From: [Marie Gallagher](#)
To: [Public Input](#)
Cc: [Sylvie Binette](#)
Subject: Written Submission for Public Input - Valleyview South Master Plan
Date: Wednesday, April 3, 2024 4:59:09 PM

Topic: Valleyview South Master Plan Submission
Name: Keith Lay (Active Trails Whitehorse Association)
Date: April 19, 2024

RE: Draft Valleyview South Master Plan (VSMP)

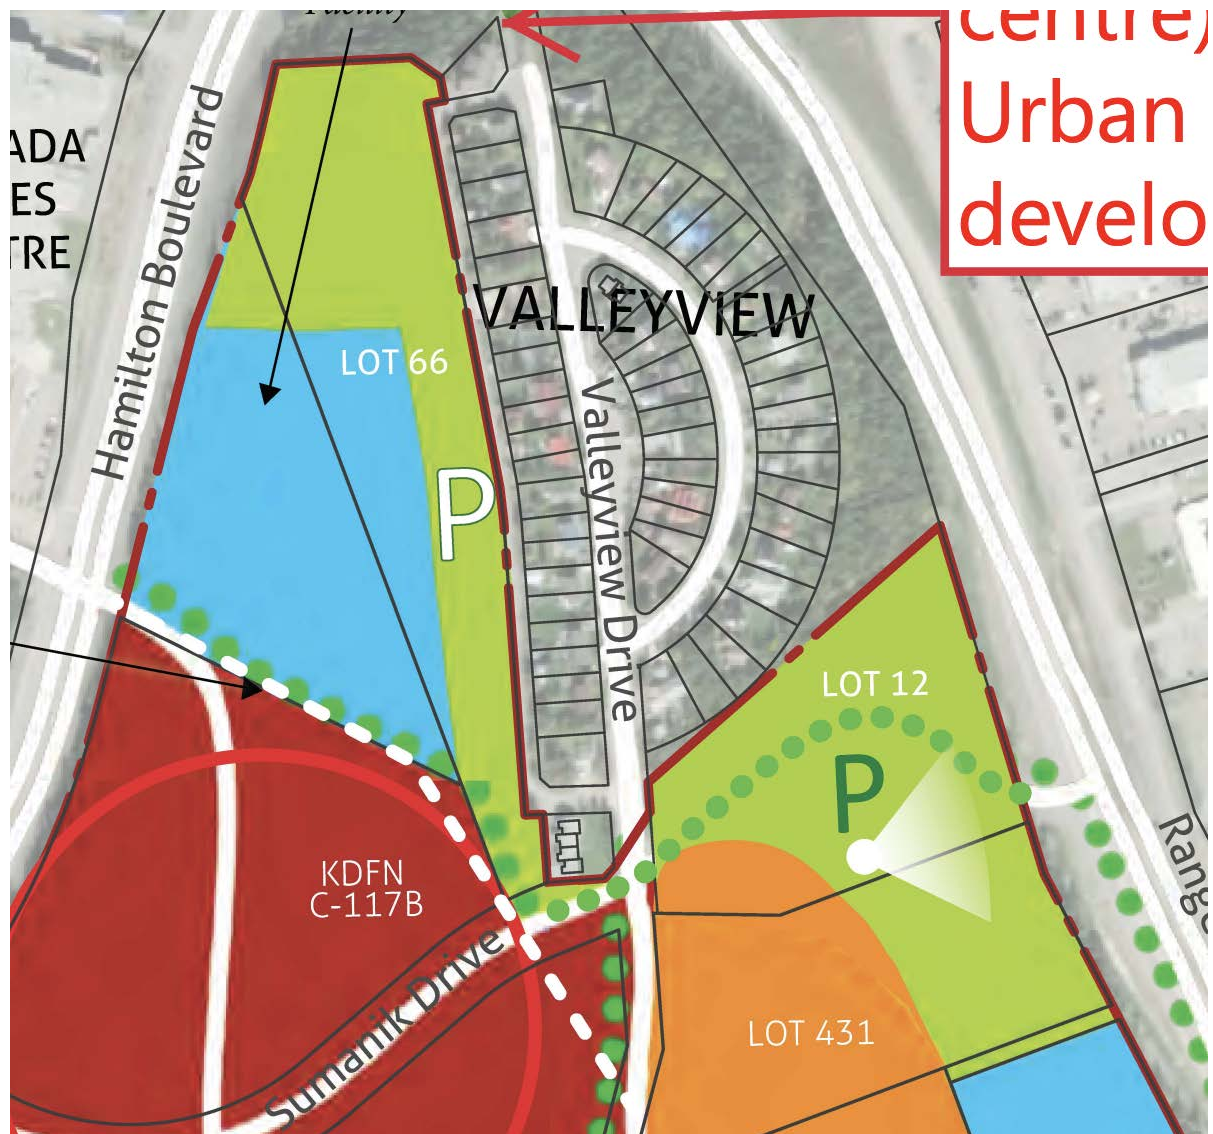
The green space being proposed for the west border of Valleyview is, by any measure, outrageously small and involves the loss of the sliding hill behind the rink as well as the existing park and the old ball diamond as well as almost all of the existing walking trails. These features would fall into the new space being proposed for a recreational facility. Also, it needs to be noted that the thin ribbon of green space between the back alley and the edge of the blue space is further diminished by the 7.5 meter zone currently being cleared by Atco for the existing power line. The thin ribbon of green space being proposed in the master plan is not consistent with Policy 21 under subsection "5.6.2 Parks, Open space and trails" (p. 36 of the Master Plan) that specifies that a minimum 60 meter vegetated buffer should be maintained between rear lot lines in Valleyview to any future development. If you look on Page 41, you also realize that the North end of lot 66 will be seriously impacted by a new stormwater management facility and a new sanitary main. **At a minimum, the entirety of Lot 66 should be maintained as green space and the 60 meter buffer should be the minimum width of the green space at any point along the alley. I am categorically opposed to developing another large recreational facility (with bright lighting, parking, traffic, snow clearing at all hours) only a few meters away from Valleyview residences.**

Also, the green space being proposed on Lot 12 is mostly unusable because of the steep slope towards the highway and also includes a transmission line right-of-way (which is not shown on the map). This small area will also be bordered by a utility corridor and lift station (see page 41). **Restoring the size of the green space (as initially proposed in Concept 2 - p. 27 of Master Plan) would at least provide some useable green space.**
